**Trans Mountain Pipeline ULC
Trans Mountain Expansion Project
NEB Hearing Order OH-001-2014
Responses to Information Request from
Dorothy Doherty**

2.1 Tunnel through Burnaby Mountain

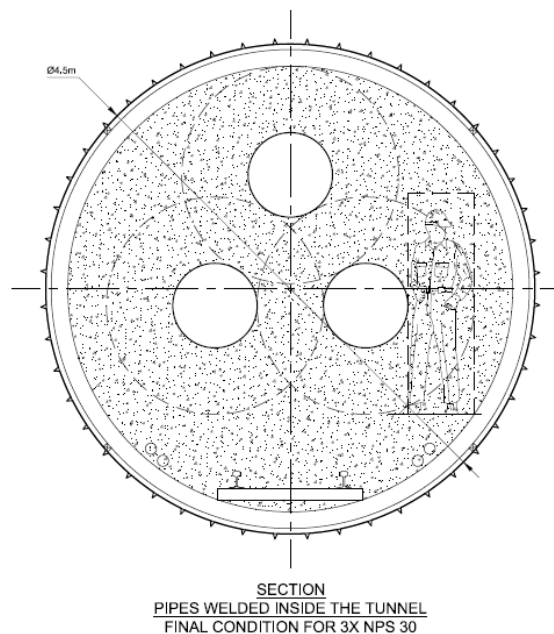
i) Please provide a diagram outlining the position of all proposed pipelines within the tunnel.

- i) Final configuration of tunnel diameter and pipe installation will depend on the selected Contractor's means and methods which may be influenced by chosen tunnel construction and tunnel backfill methods.

As a representation only at a feasibility level stage, the following backfilled pipe arrangement may be appropriate. Note that the third pipeline is shown indicatively only for approximate sizing purposes.
